VERMONT YANKEE NUCLEAR POWER CORPORATION

May 4, 1984
FVY 84-43

Subject: NUREG-0737, Item II.B.3, Post-Accident Sampling System

Vermont Yankee Response to
Request for Additional Information

SK-79-51-1

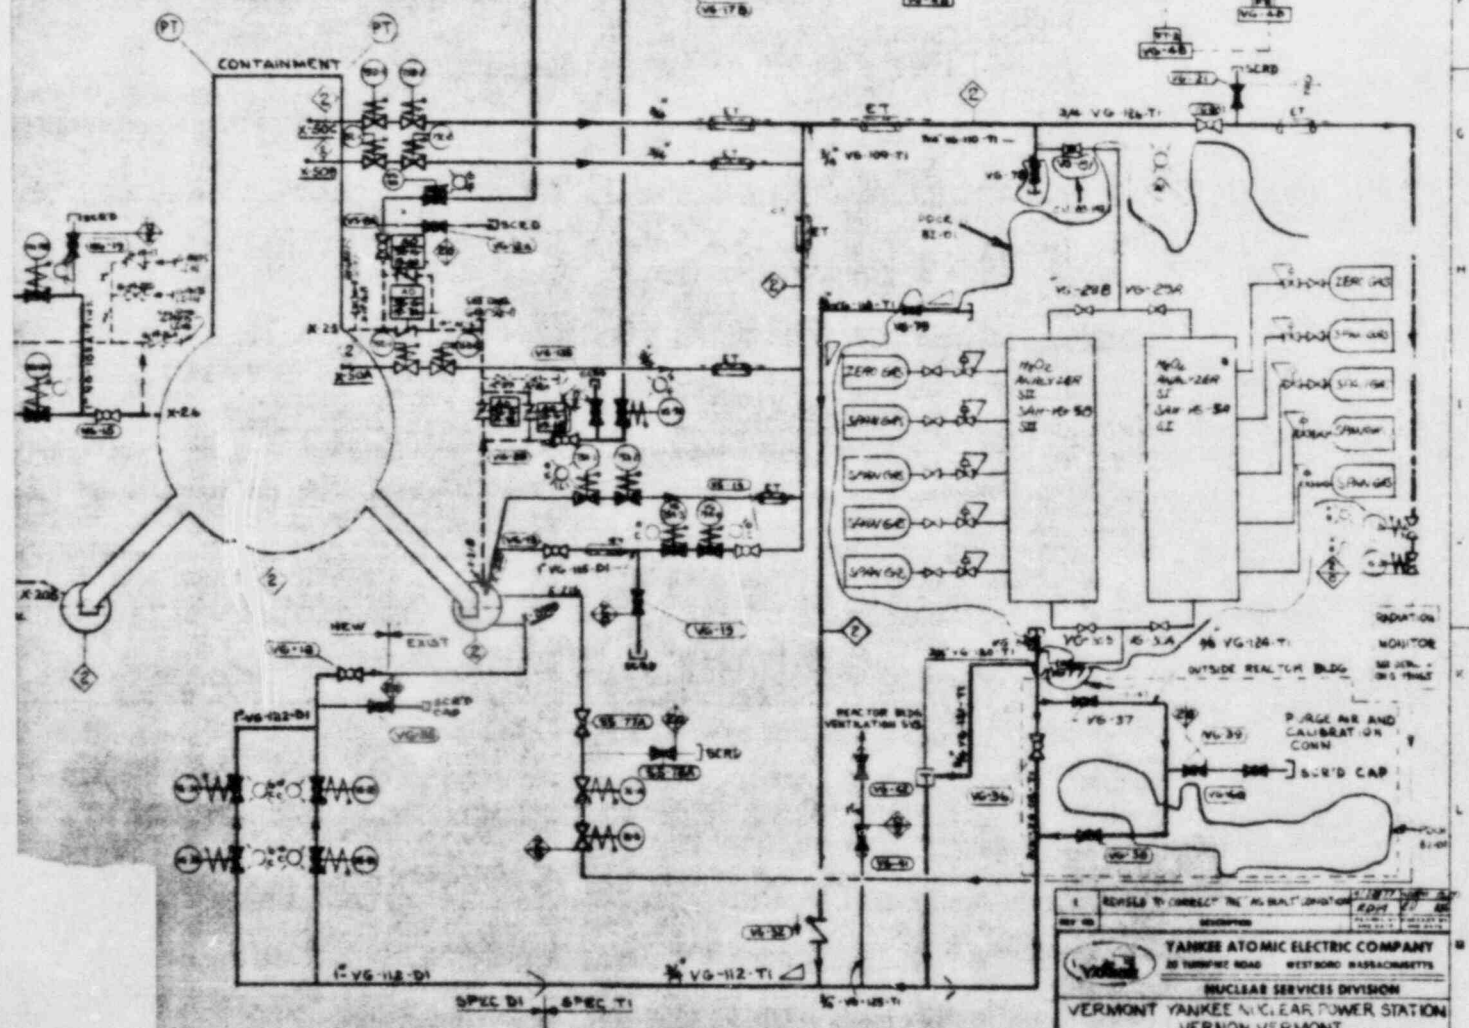
The Containment Atmosphere Sampling System draws gas samples from the primary containment and returns the sample purge flow to the torus. Inside containment, both of these lines are open-ended to the containment atmosphere (see Sketch SK-79-51-1, Attachment A).

The Containment Atmosphere Sampling System draws containment air samples from a point downstream of the hydrogen/oxygen monitors.

Purging of the sampling lines is accomplished by establishing flow through the hydrogen/oxygen analyzers using the analyzer sample pumps. Removable sample cylinders can be installed downstream of the analyzers with bypass lines to allow continuous sample purging. Presently, we are evaluating the sampling system to determine the need to further reduce plateout and minimize distortion in the sample lines.
